*Date:* September 14, 2023  
*Case No.:* **2019-020115ENV**  
*Project Title:* **Ocean Beach Climate Change Adaptation Project**  
*To:* Members of the Planning Commission and Interested Parties  
*From:* Lisa Gibson, Environmental Review Officer  
*Re:* Responses to Comments on the Draft Environmental Impact Report for the Ocean Beach Climate Change Adaptation Project

RESPONSES TO COMMENTS

# Ocean Beach Climate Change Adaptation Project

Case No. **2019-020115ENV**

**Revised Figure 2-6**  
Conceptual Cross Sections of Access Improvements  
Proposed for South Ocean Beach

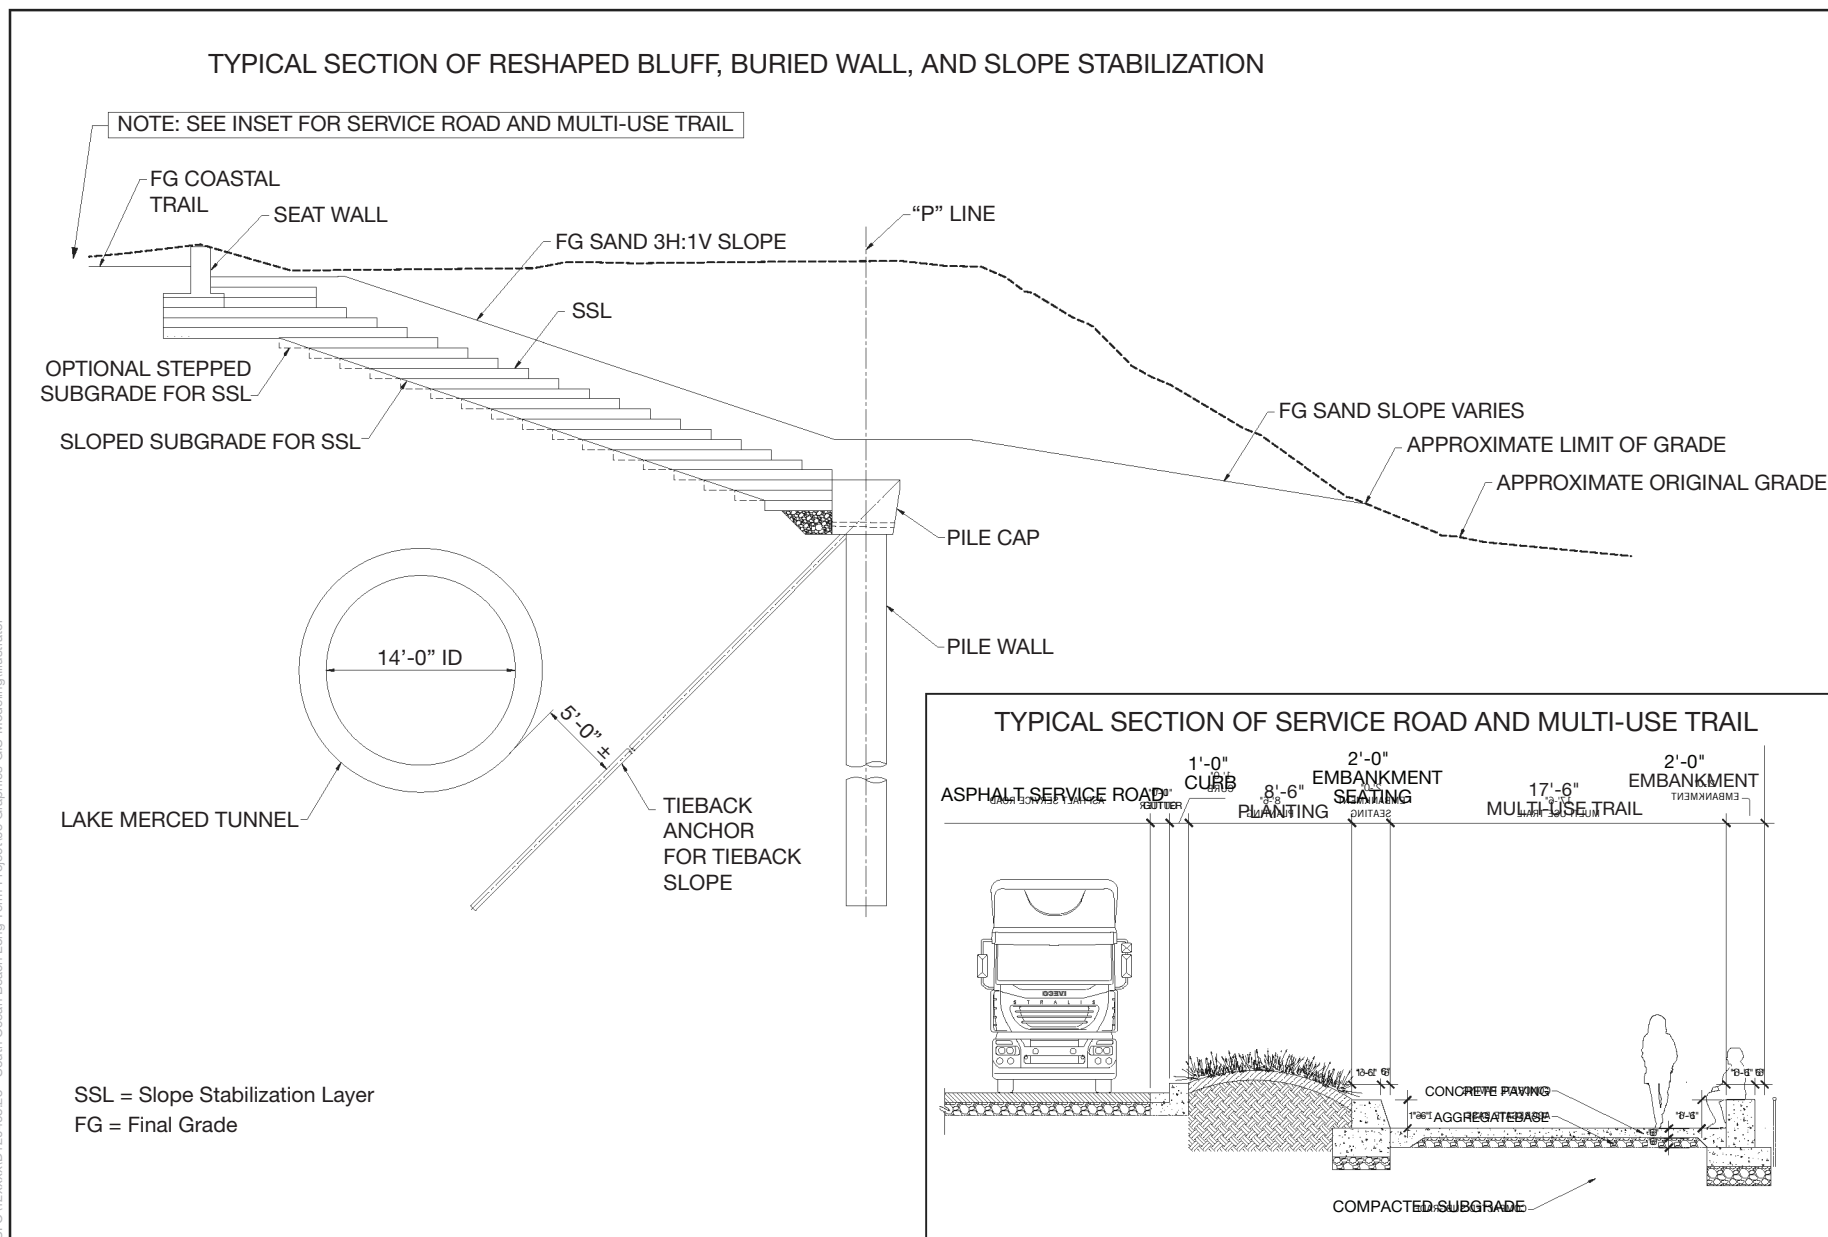
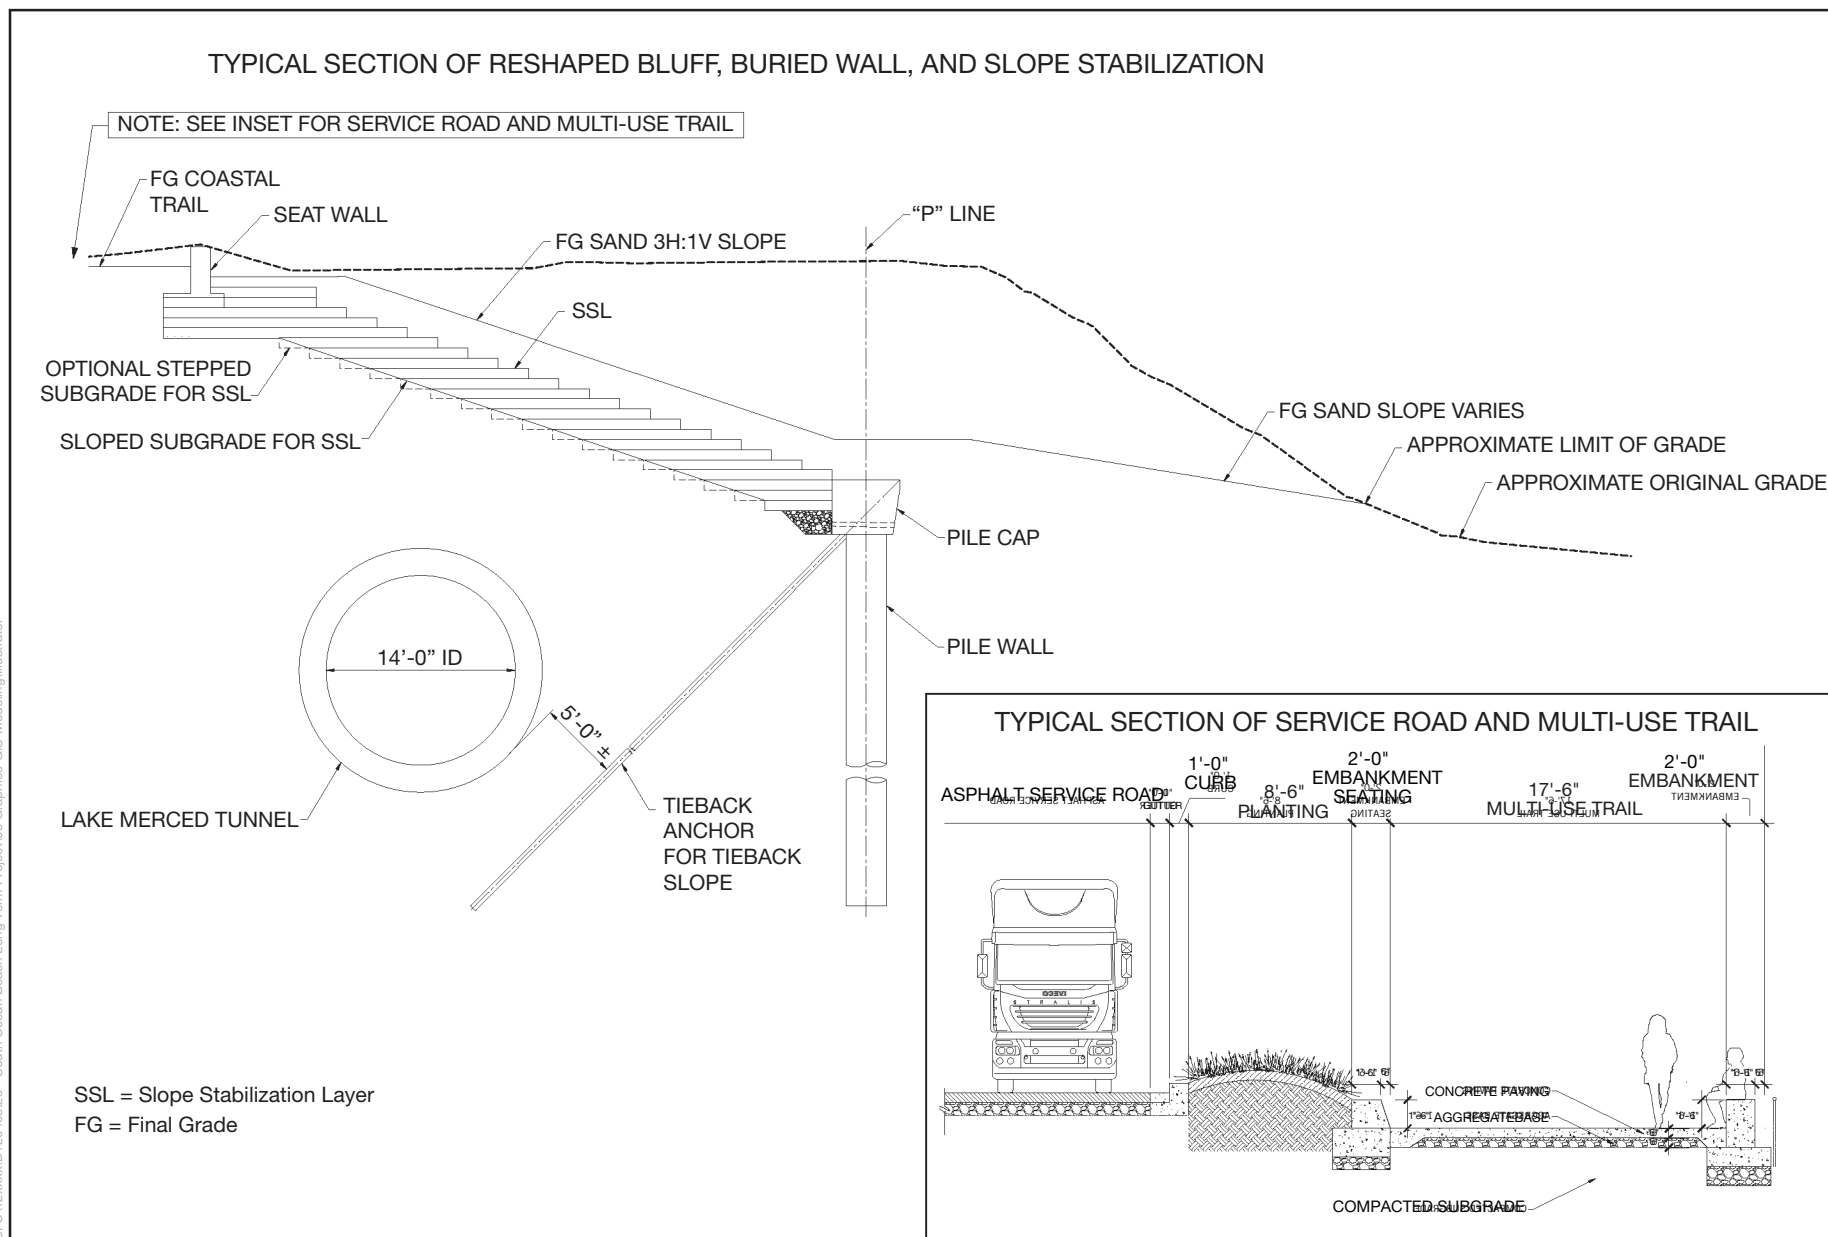
“So with that, I just wanted to have -- I do have a couple of clarification questions that I would hope would be addressed in the response to comments. The first is that I find figure S-3 which is the same as 2.6 which is the same figure Ms. Moore put up at the beginning of her presentation, is somewhat challenging to read, especially in the EIR. It's very faint, it's hard to tell the dash lines from the straight lines. There's not enough labeling. There's a circular symbol which I assume is the tunnel, but it's not labeled as tunnel. Just sort of simple things that would make it easier for the public to understand. That's a very important cross-section.” (Sue Diamond, Commissioner, San Francisco Planning Commission [A-CPC-1.1])

In response to the comment (A-CPC-1.1) suggesting changes to draft EIR **Figures S-3 and 2-6**, the text in these figures has been enlarged and the tunnel labeled as shown on the following pages. Also, weight has been added to the dashed lines to increase their visibility. Similarly, in response to the comment (A-CPC-1.3) requesting clarification on the green line shown in draft EIR **Figure 2-2**, the figure has been revised as shown below to include a label identifying the green line as a designated bicycle lane along the service road. Revised Figure 2-2 also updates another label to be consistent with project description revisions in Chapter 9.

The text in **Figure 2-6** on draft EIR p. 2-15 has been enlarged and the tunnel labeled as shown on p. 12-35 of this RTC. Also, weight has been added to the figure's dashed lines to increase their visibility.

A-GGNRA.13

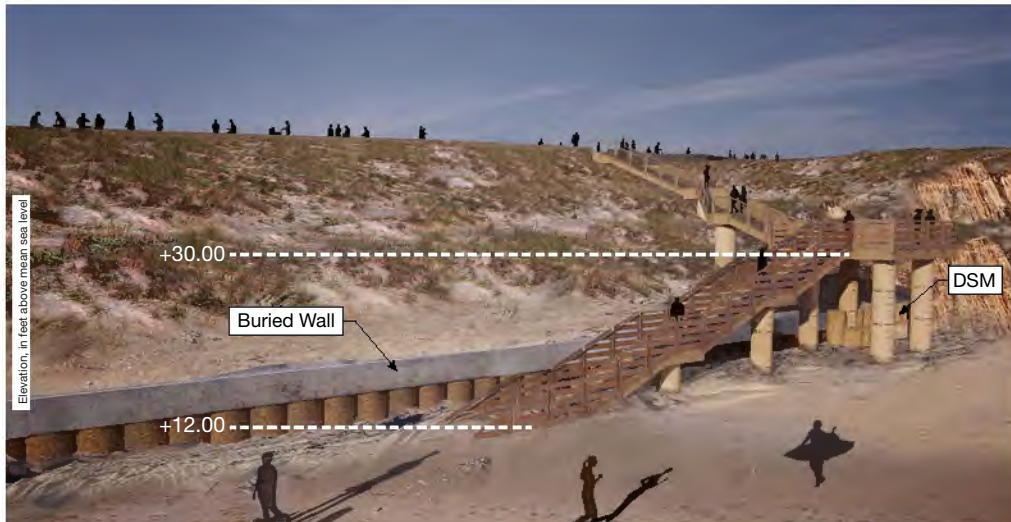
**“Table 4.1-3 Projects Considered in Cumulative Impact Analysis and Fig 4.1-1 Cumulative Projects:** The tables and analysis need to include the recent USACE beach nourishment project.” (Laura E. Joss, Golden Gate National Recreation Area, National Park Service, United States Department of the Interior [A-GGNRA.13])

Draft EIR **Figure 4.1-1** has been revised to reflect additional cumulative projects, as shown on the following page.

**Revised Figure S-1b**  
Project Elements Proposed for North Ocean Beach

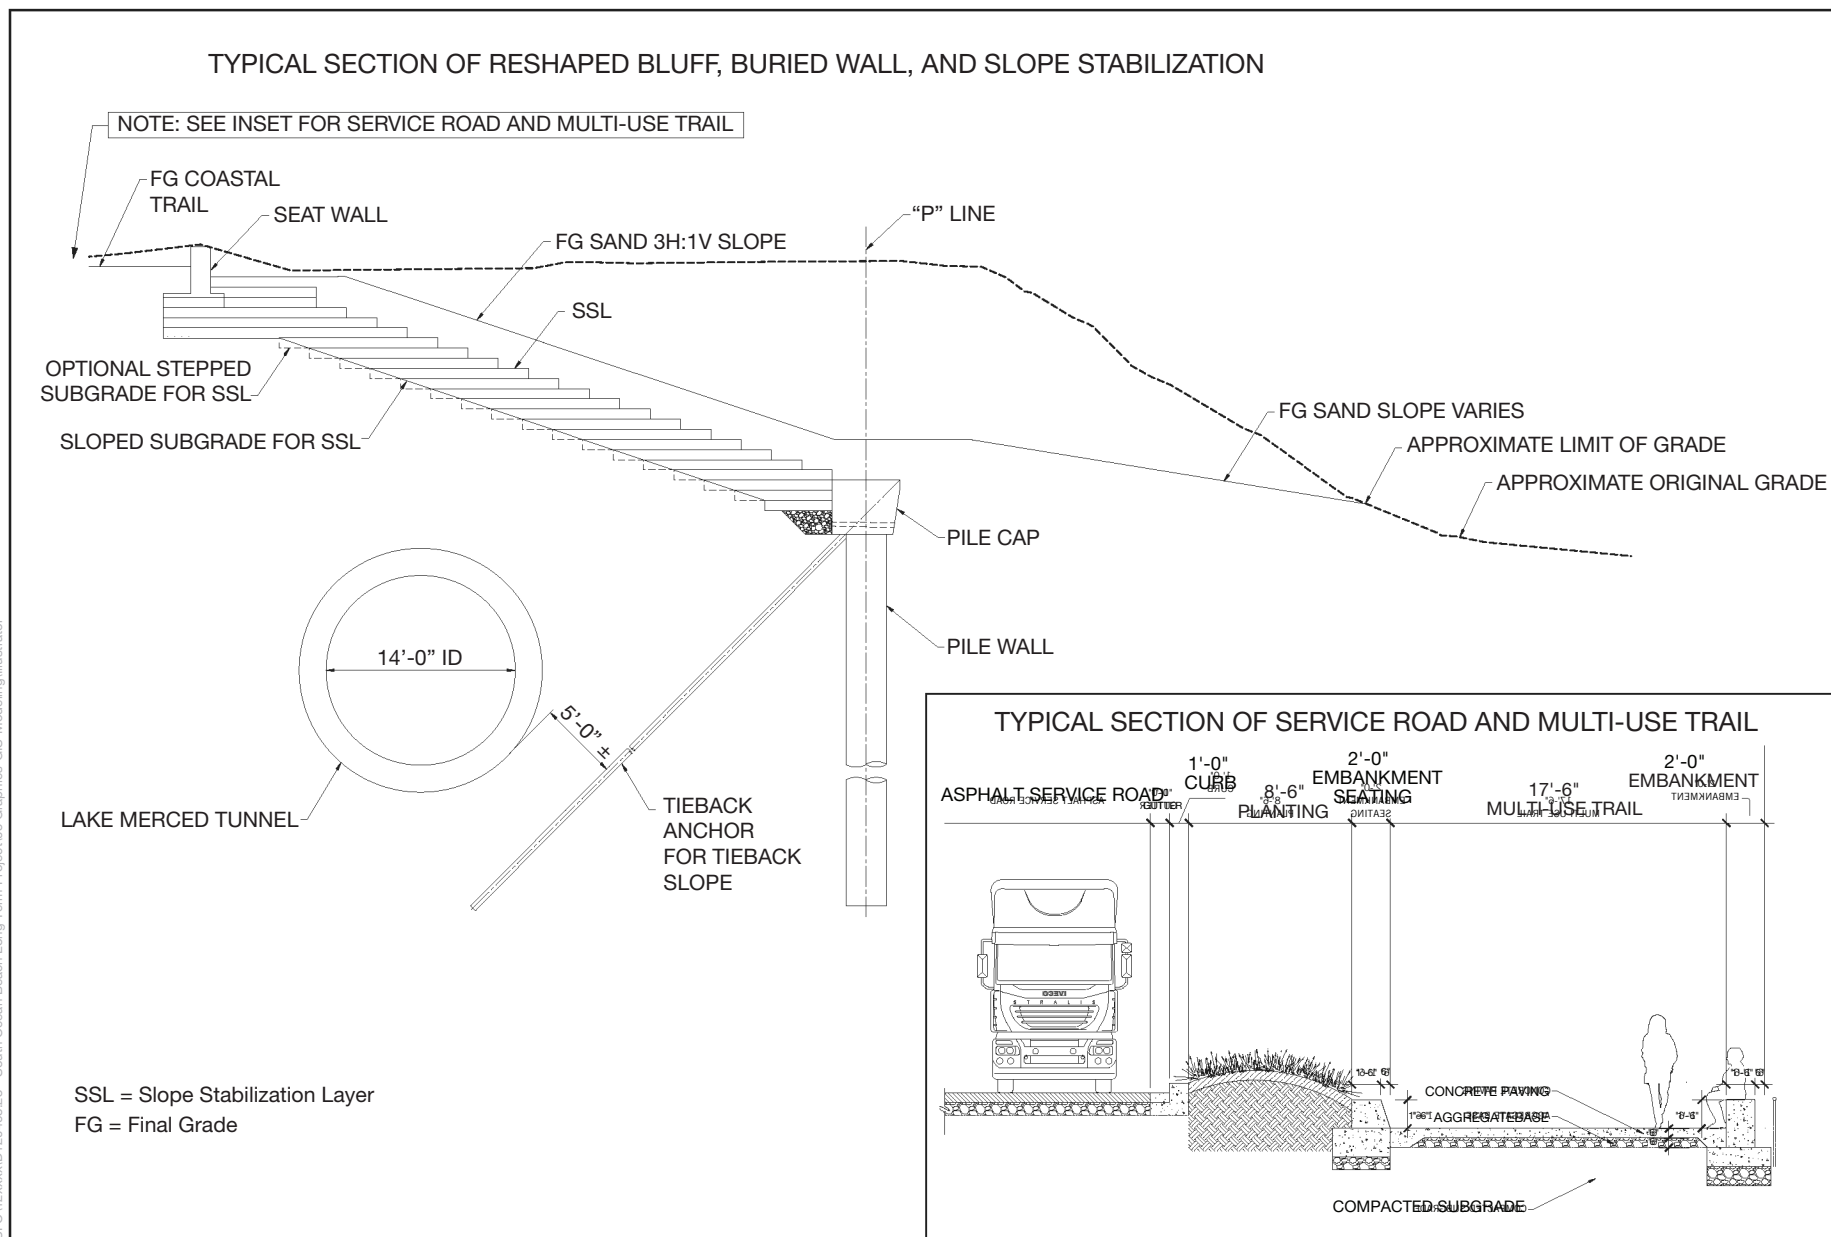
“**SUMMARY, S.3.1 and S.3.6., Fig S-1b:** Regarding long-term beach nourishment, clarify that sand removal at North Ocean Beach, a federal property managed by GGNRA, will remain at the discretion of GGNRA and continuation will be dependent upon avoiding significant impacts on resources and recreation. Add a note to

Figure S-1b with same clarification.” (Laura E. Joss, Golden Gate National Recreation Area, National Park Service, United States Department of the Interior [A-GGNRA.8])

In addition, the following note has been added to EIR Figures S-1b and 2-1b:

The following note has been added to Figure S-1b on draft EIR pp. S-5:

Sand removal from North Ocean Beach for beach nourishment at South Ocean Beach would require GGNRA approval.
